Access Compliance Report

Public Rights-of-Way

(Curb Ramps)

| Intersection ID: 12545 | Main Street: S_POPLAR_ST | Cross Street: W_STONEWALL_ST | Location: S |

| ADA ID: CAF2A28615C6 | Ramp Type: PerpDiag | Initial Pass/Fail: Fail | Overall Compliance: No |

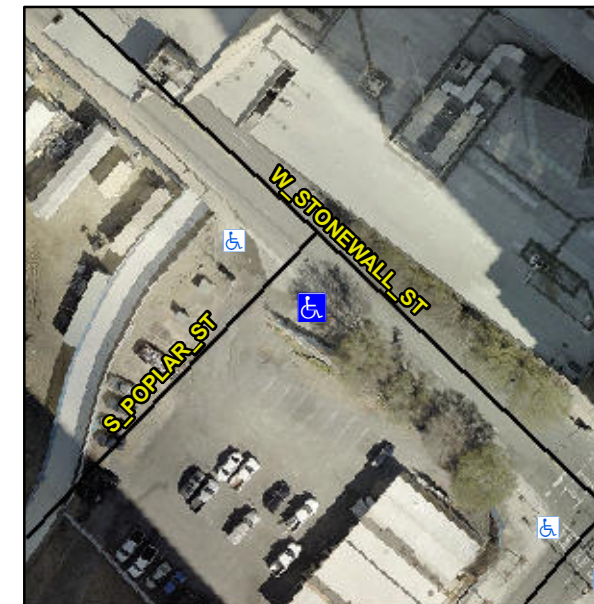
R304.2.2, R304.5.3

| Compliance | Description | Data | Compliance | Description | Data |
|------------|-----------------------|-------|------------|-----------------------------|-------|
| N/A | Ramp Length (in) | 37.0 | No | Ramp Slope (%) | 9.4 |
| Yes | Ramp Width (in) | 76.0 | No | Ramp XSlope (%) | 6.2 |

Remove & Replace Curb Ramp With Two New Directional Ramps or Equivalent.
